## **SALT HRS Team Response to CDR report**

### **Response to Section 3: 'Agreed Statement by Panel'**

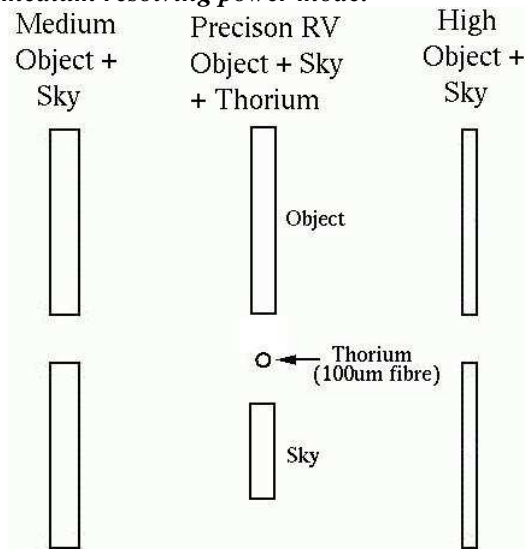
**E.** (linked to **K**) It is recommended that the team should consider whether there should be available different-width slit-masks optimised for either i) high throughput, or ii) optimal integrity of radial velocity. These might need to be remotely interchangeable.

**K.** (linked with **E**) The panel believes that it would be prudent for the team to consider the simultaneous injection of ThAr, and/or the inclusion of an iodine cell, to realise the full radial-velocity potential of HRS at first-light.

*We propose to implement a single high precision radial velocity mode. This mode will be additional to the modes already proposed and will involve dedicated image slicers. These image slicers will be optimised for radial velocity precision. This mode will incorporate fibre double scramblers. Implementation of this mode will have a significant cost including a design study of the optimal configuration. We will continue to offer sufficient physical space for an iodine cell as a possible future upgrade.*

*In order to accommodate the high precision radial velocity mode the slit plate will be modified. A possible layout is shown in Figure 1. Note that this design assumes the same form of image slicers are used as in the medium resolving power mode.*

Figure 6: Optical bench support showing lever and weight. The echelle grating is at top left.

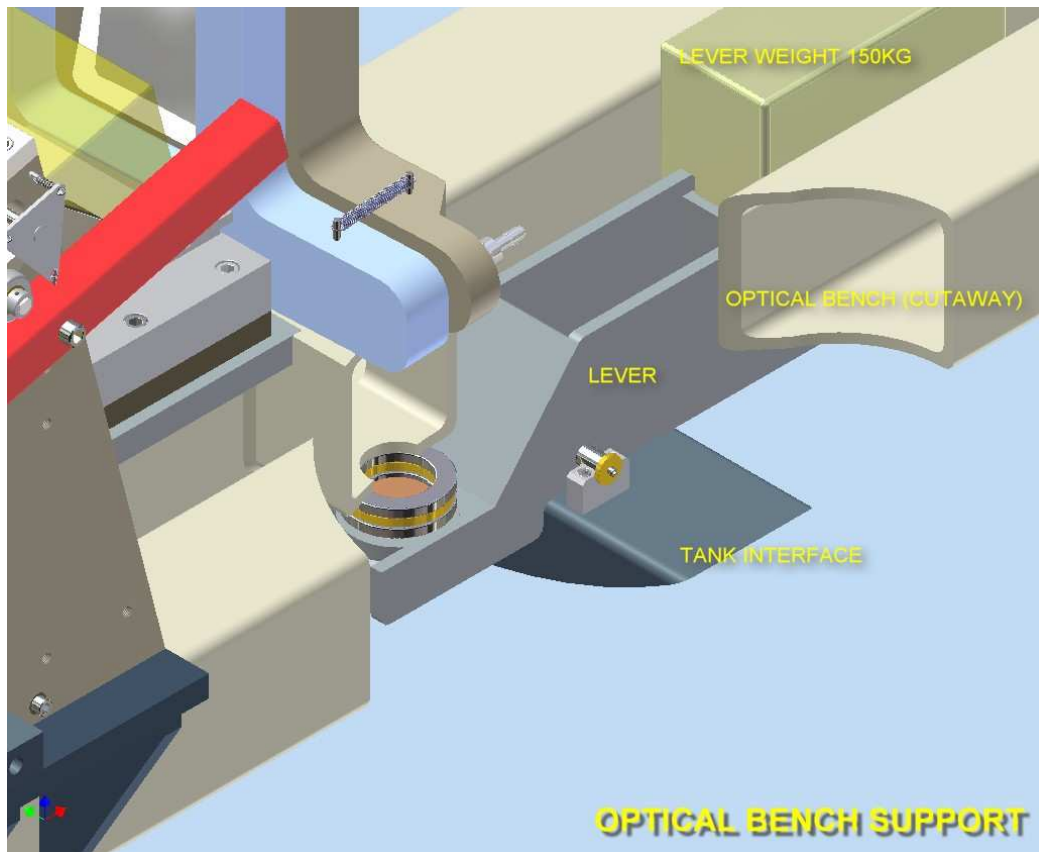
**S.** The current interface of the bench and tank, relying on multiple attachments at the camera-lid, plus rollers on the opposite side, is over-constrained. It is recommended that alternative solutions are explored that remove the constraints imposed by the hard-line contact of the rollers. Possible solutions could be as simple as supporting the bulk of the mass of the bench with internal counterweighted levers.

*Since the CDR review a redesign of the input/output lid has been completed. Maximum deflection of this lid is approximately 6 microns, atmosphere to vacuum (c.f. 23 microns at CDR). The camera lens mountings are now the only coupling points to the optical bench. A pair of weighted levers support the optical bench inside the tank, each taking approximately 150kgs of the load. Thrust bearings are used to decouple these levers from the tank. A full FEA of the optical bench has shown very favourable results (see figures and FEA below).*

Figure 8: The revised input fibre assembly stage, showing the extended platform and clamping arrangement.

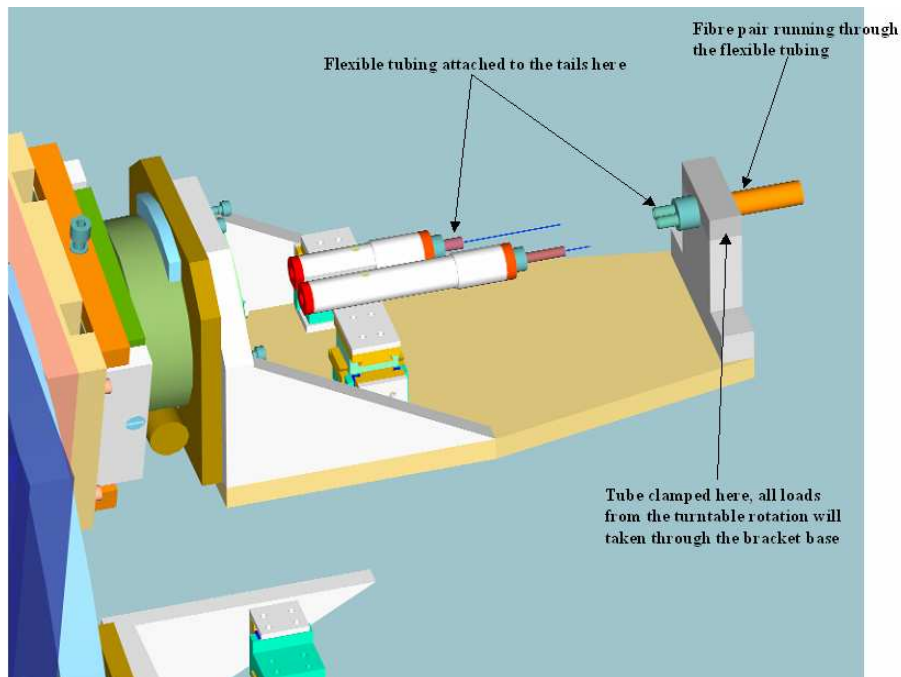
X. The panel is not convinced that the present concept of stacked stages will provide adequate stiffness and stability. The team is encouraged to investigate integrated multi-axis flexural stages, such as are marketed for precision fibre-positioning.

*We have re-investigated this aspect of the design. We have found X-Y flexure stages from ThorLabs that will replace the custom made table proposed for the fibre input. Also from ThorLabs is a precision rotating table that can take a 2.5kg vertical loading, which would be very suitable for this application. We still propose to keep the three stacked micropositioners, as they are the best solution for moving the fibres with respect to each other and the image slicers. We have extended the platform that they are attached to and have a clamp to hold the tubing that the fibres are inserted in – see Figure 8.*
